July 9, 2020

Mr. Michael O’Harra
Southern Region Regional Administrator
Federal Aviation Administration
1701 Columbia Ave.
College Park, GA 30337

The Charlotte Douglas International Airport Community Roundtable (ACR) is hereby submitting a slate of six recommendations for the FAA to consider implementing to reduce the airplane noise effect on the population resulting from recurring overflights of aircraft arriving and departing Charlotte Douglas International Airport (CLT).

Recommendation 2: Maintain 6,000' Arrival Minimum Altitude until Final Approach Course

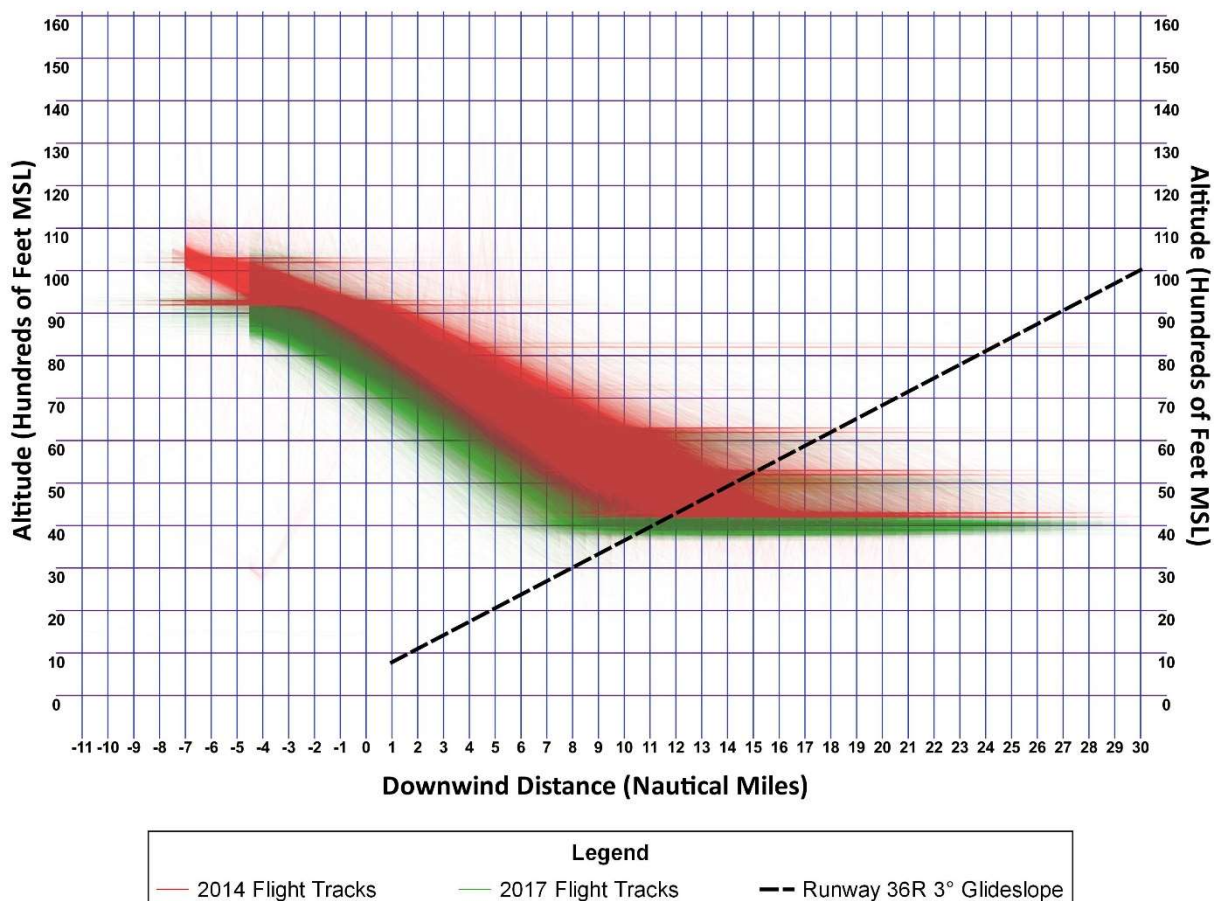
Raise the minimum altitude for aircraft to maintain 6,000 feet MSL¹ on arrival until they intercept the 3-degree glide slope for each runway. Raising the minimum altitude on the extended arrival legs is expected to reduce noise levels along the extended arrival legs, particularly for those aircraft at high power to maintain level flight.

The ACR is proposing that no aircraft be permitted to descend below 6,000 feet MSL until a reasonable estimate of joining the final approach on the 3-degree glideslope can be made. This adjustment to arrival procedures would provide a clear, demonstrable reduction in noise levels in areas along the existing downwind approach and straight-in arrivals, which encompasses nearly 320 square miles. Under preliminary analysis using the above ACR criteria this recommendation is expected to have a net benefit in noise reduction to over 376,000 residents in the Charlotte Metropolitan area. Further details can be found in Appendix pg. 35.

Recommendation 4: Remove the 2-Mile Restriction on Departure³

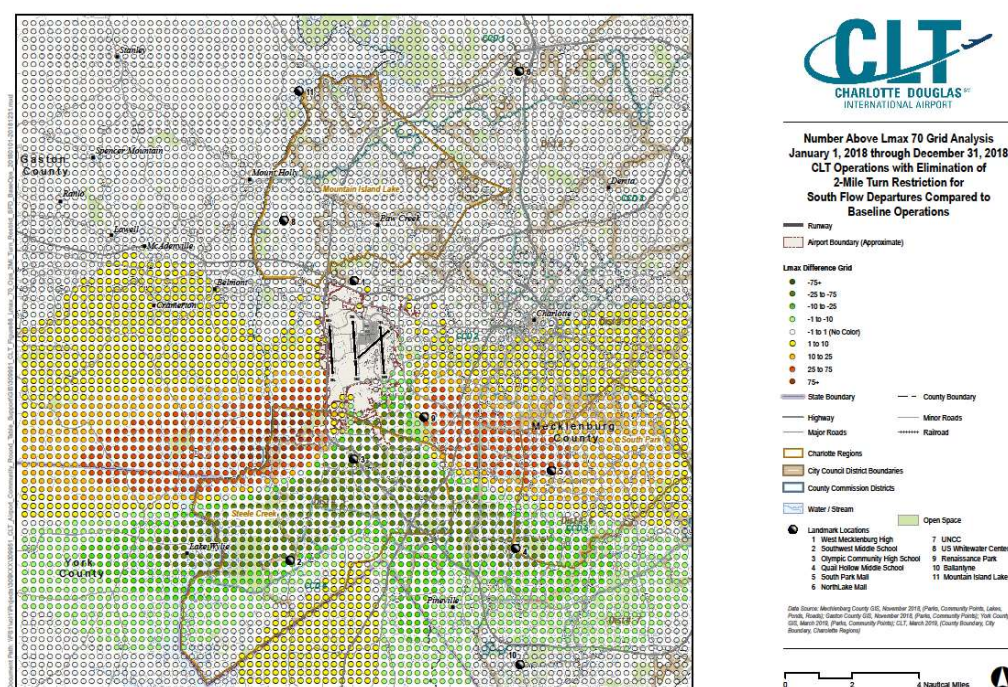
Currently, southern departures from CLT cannot turn until they are 1.6 miles DME from the runway end. Eliminating this restriction would allow aircraft to turn on course sooner, thereby reducing noise impact over communities along the extended southern centerlines but shifting the noise closer to the airport and along east and west areas where turns would then occur. This alternative modified flight tracks so that aircraft turned on course upon reaching a safe altitude near the runway's departure end. Implementation of this recommendation would be dependent on other departure-based recommendations, i.e.; this recommendation would not be supported without implementation also of divergent headings, changed initial turns, etc. See Section C: Grouping and Prioritization.

Under preliminary analysis using the above ACR criteria, this recommendation as a standalone is expected to have a net increase in noise for over 166,000 residents. As such this recommendation cannot be implemented without an appropriate reduction in noise over an associated area by implementing one or more of the other departure recommendations. Further details found in Appendix pg. 38.

Recommendation 5: Utilize Divergent Departure Headings

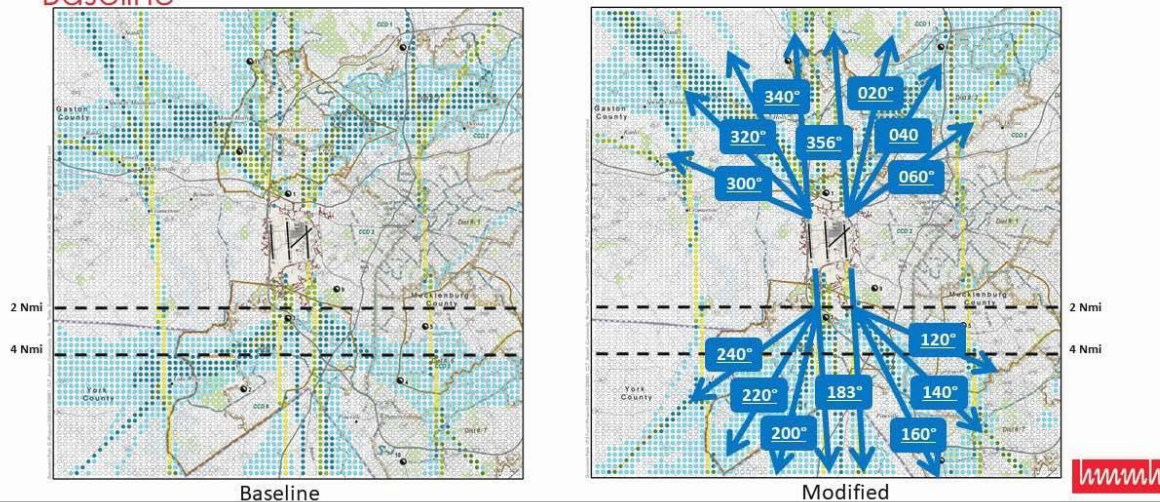
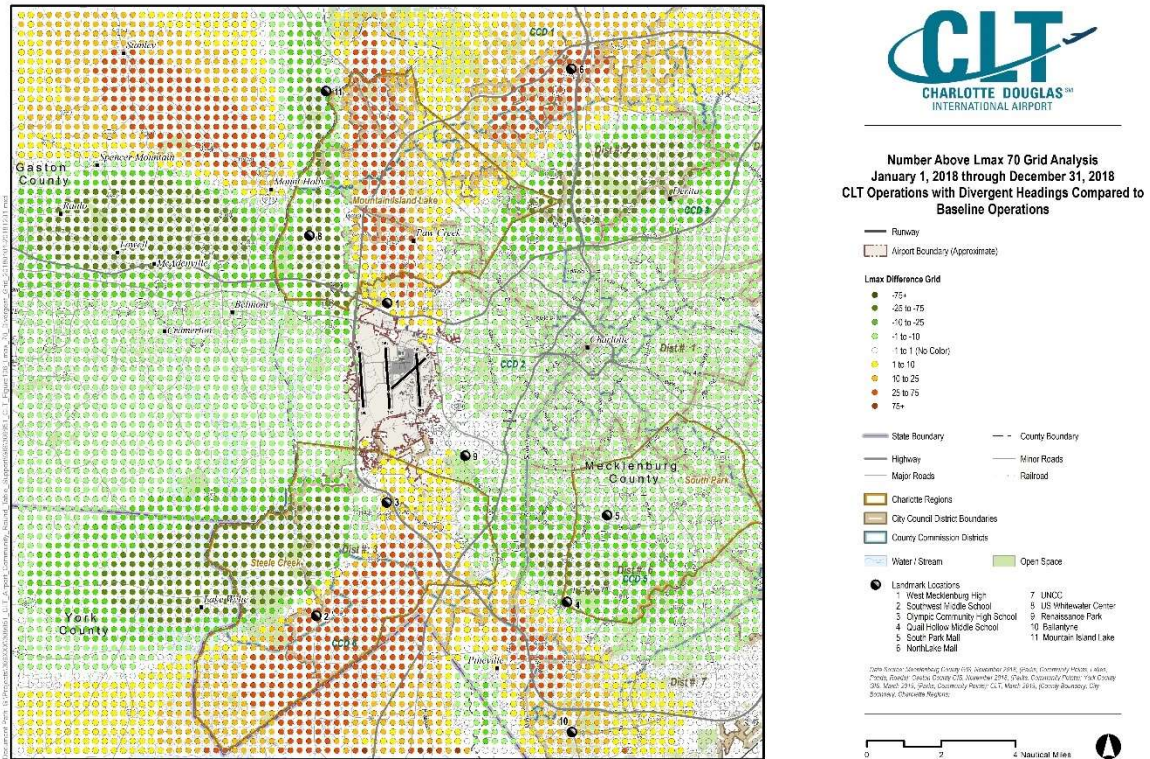
The divergent departure heading alternative assigns departure headings based on the aircraft's destination. These variable headings not only allow aircraft to fly a more direct path to destination, resulting in time and fuel savings for operators, but also disperse traffic over a wider area, dividing the noise effects over multiple communities. This analysis used 7 headings for both north and south flow departures, for a total of 14 headings. These headings diverged at the runway end for north flow and at 2 miles from the runway end for south flow. However, it is possible that this recommendation be combined with the removal of the two-mile restriction recommendation to improve efficiency as long as those aircraft are relatively equally dispersed among all divergent headings.

Under preliminary analysis using the above ACR criteria, this recommendation is expected to have a net benefit in noise reduction to over 112,000 residents in the Charlotte Metropolitan area.

Recommendation 6: Change Headings of First Turns off Runways 18L and 18C

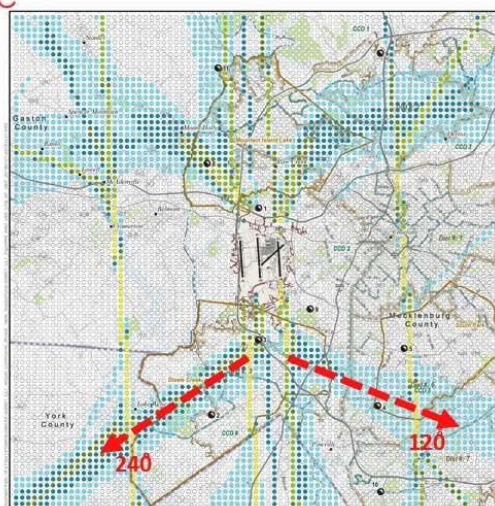
After departure, aircraft turn to a given heading. This alternative proposes a change to this specified heading so that they fly over communities that they flew over prior to the FAA's implementation of the Metroplex, which tend to be less populated areas. This reduces the effect of noise on more densely populated areas and fosters the desire by the ACR to return to pre-Metroplex flight paths. This analysis changes the headings for east and west departures by 30 degrees, from 270 to 240 degrees for west departures and 090 to 120 degrees for east departures. Under preliminary analysis using the above ACR criteria this recommendation is expected to have a net benefit in noise reduction to over 524,000 residents in the Charlotte Metropolitan area.
